Product / Process Change Notification (PCN)

PCN Number: PCN_IndLHCA_20250228

Affected Series: WE-LHCA

Details of Change:

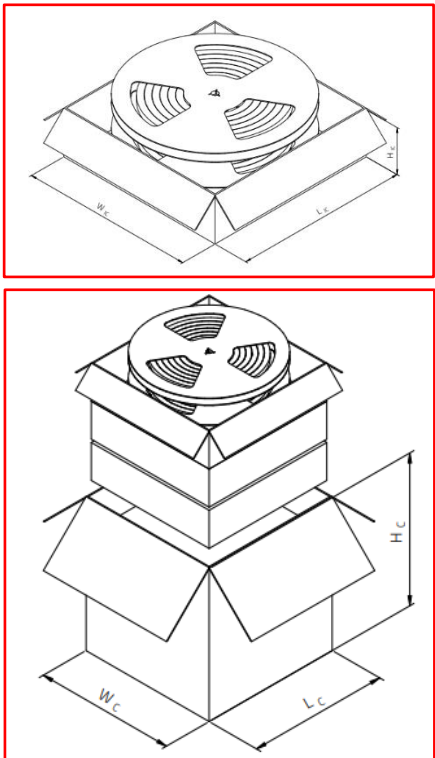
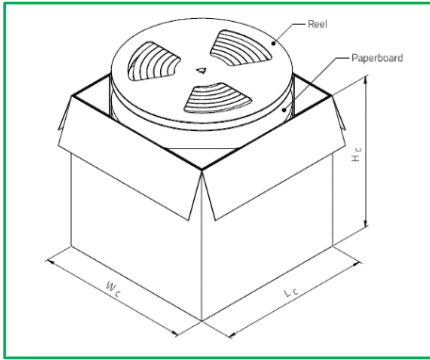
1. To reduce the amount of packaging waste in the product series WE-LHCA, with sizes and order codes indicated in table 1, the inner boxes will be omitted. No plastic filler will be used, and every reel will be stacked and separated by paperboard. The outer box dimension, reel quantity (pcs.), and box quantity (pcs.) will be updated accordingly. Additional details of the changes can be found in the table below:
